Submissions Report

WELLINGTON SOLAR FARM

MARCH 2018

Figure 3-2 Updated constraints mapping, reflecting new layout and additional assessments presented in this Submissions Report.

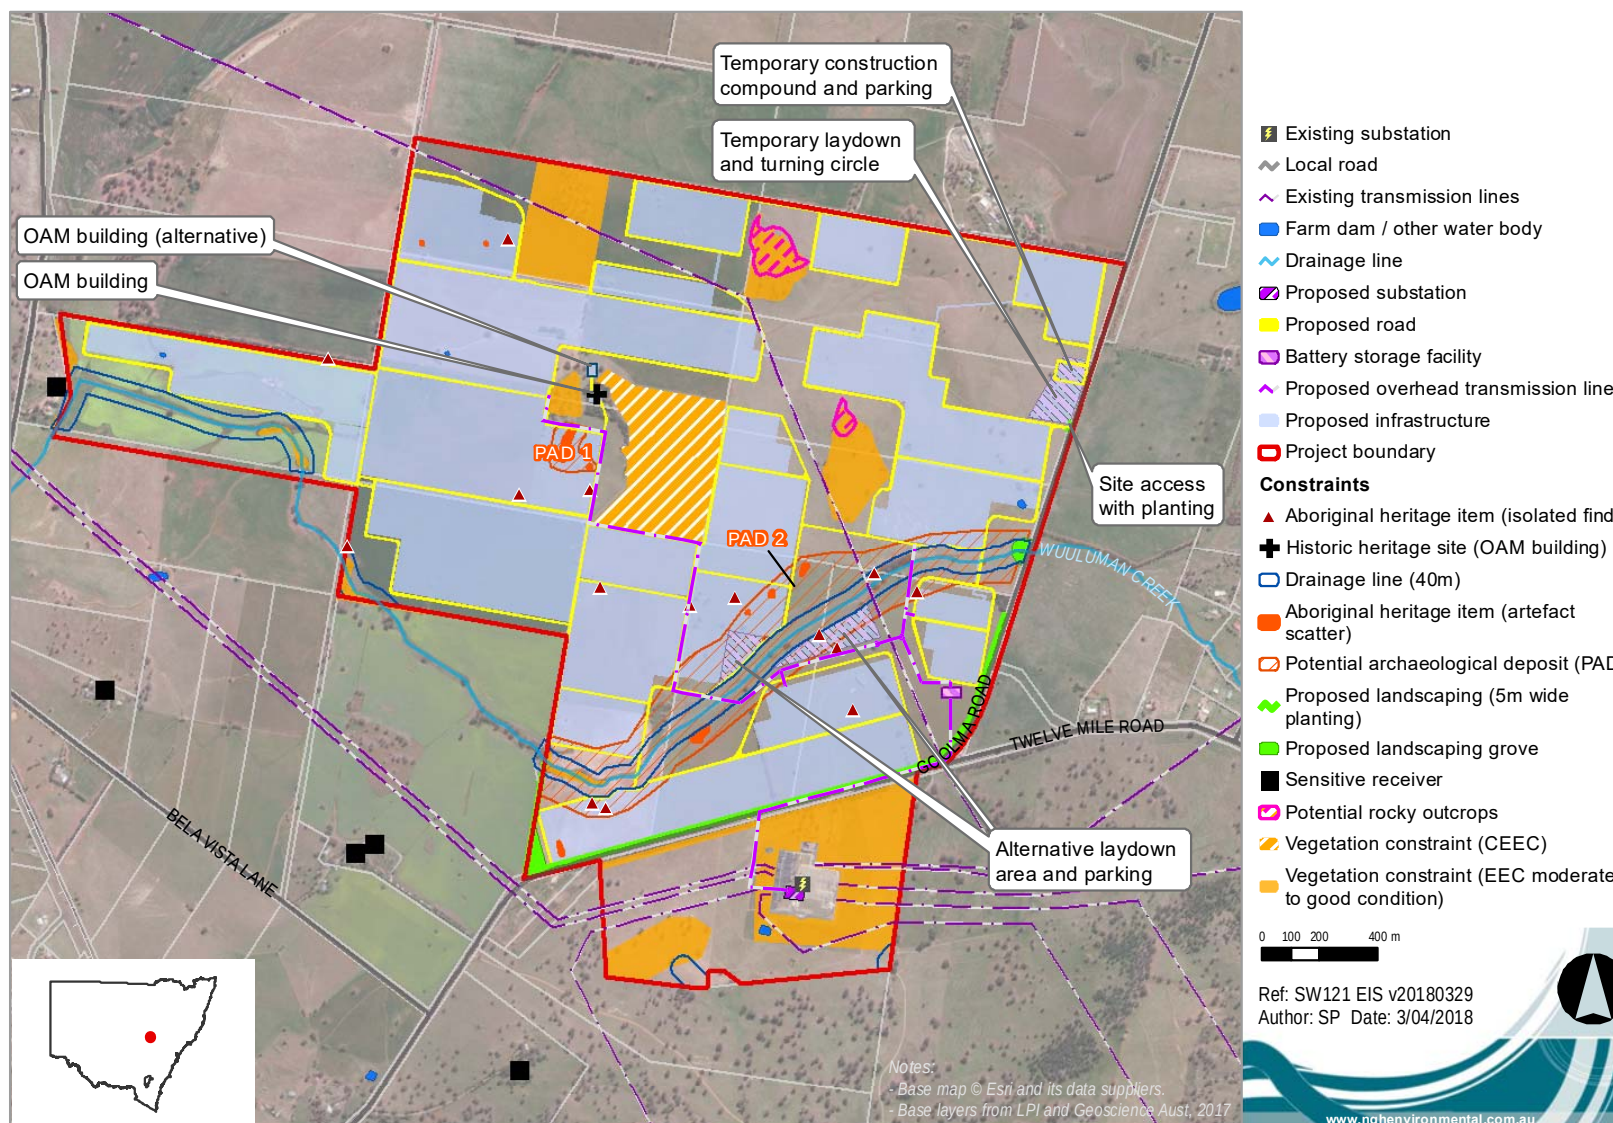
Issue	Detail of issue	Proponent response
6.1 DEPARTMENT OF PLANNING AND ENVIRONMENT (DPE)		
Revised disturbance areas	Describe the revised layout, noting the CEEC will be avoided. Confirm which substation option will be used and revise the project boundary to reflect the final option.	The updated indicative layout and constraints map is provided in Figure 3-2. The changes are: • The project footprint has been reduced to reduce impacts on a CEEC. The overall reduction on this community (which is now entirely avoided) is 2.075 ha. The overall reduction on native vegetation impacts is 9.83 ha. • The alternative substation location south of the Energy Storage Facility (ESF) has now been deleted. The substation would be located in the western part of the existing substation within the substation boundary fence. • The 33kV feeders from the solar farm will run underground along the boundary of the solar farm, under Goolma Road and into the substation, reducing the visual impact of additional overhead power lines. • An additional option has been included to construct a purpose-built Operations and Maintenance building near the onsite residence. This option is required in the event that upgrades anticipated for the historic structure are not cost effective or in keeping with the heritage restrictions on this structure.

Further information required to make assessment	Layout of internal road network, parking facilities and infrastructure within project boundary.	The proponent has provided an updated layout (Figure 3-2) showing the internal road network, parking facilities and infrastructure within project boundary. No changes to the EIS mitigation measures are proposed.
Further information required to make assessment	In their response, Roads and Maritime restated the need to provide information requested in their SEARs provided 30 June 2017. Roads and Maritime SEARS included the following additional items: • A Traffic Impact Study prepared in accordance with Section 2 of <i>RTA's Guide to traffic</i>	The proponent discussed the request by RMS for further information. RMS's key issue was traffic numbers and management as addressed above. The proponent's understanding is that no further action was required. Specifically: • As separate TIS is not required. • Additional road improvements are not required. • Further consideration of local climate is not required.

The updated indicative layout and constraints map is provided in Figure 3-2.
